From: Brenda Connelly <coolyback@optusnet.com.au>
To: <thomas.fitzgerald@planning.nsw.gov.au>
CC: <assessments@planning.nsw.gov.au>
Date: Wednesday - March 30, 2011 9:24 PM
Subject: Online Submission from Brenda Connelly (object)

Submission for Job: #3509
https://majorprojects.affinitylive.com/?action=view_job&id=3509

Site: #2109 Residential subdivision at Fraser Drive, Terranora
https://majorprojects.affinitylive.com/?action=view_site&id=2109

I wish to object to the development proposal (09_0166 - Residential subdivision) by Metricon on the following grounds:

FIGURE 1

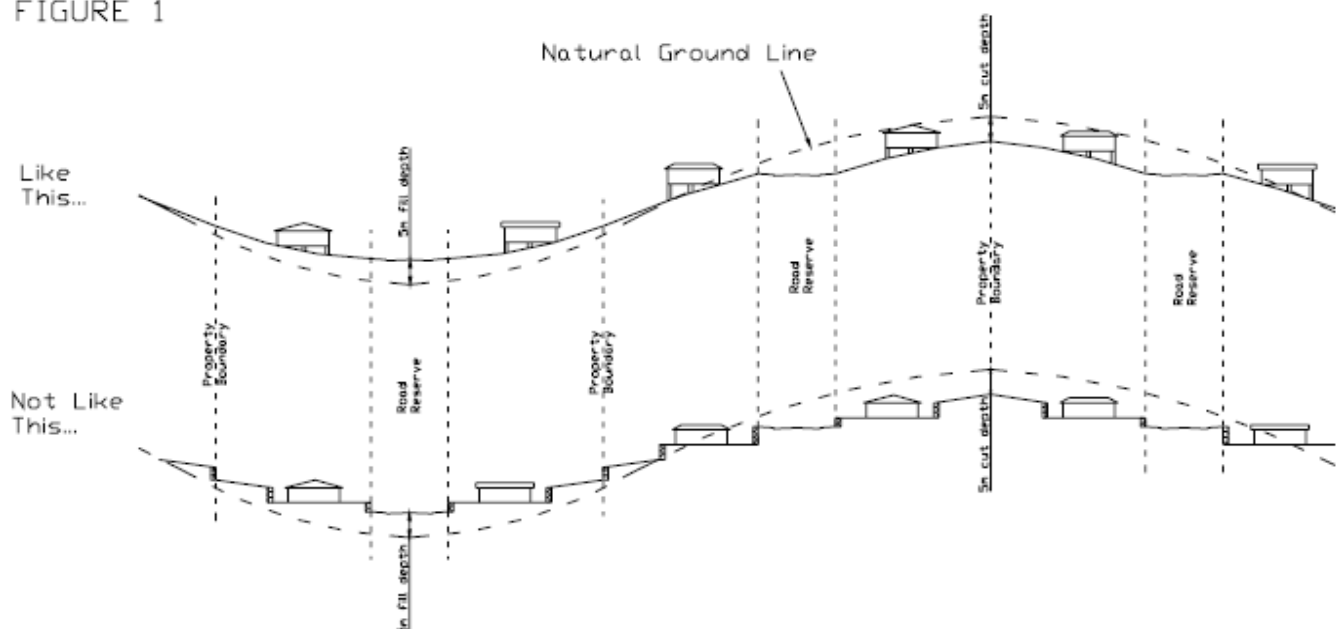
By understating the scenic impact of the massive landforming and retaining walls, LVO is simply delivering an assessment that the developers require to avoid the scrutiny of State Planning. From many properties in Parkes Lane, their view will consist of a highly altered landform with up to 15 terraced and retained building platforms with a backdrop of a 3 metre rock wall with a 2.4 metre acoustic wall on top bordering Fraser Drive.
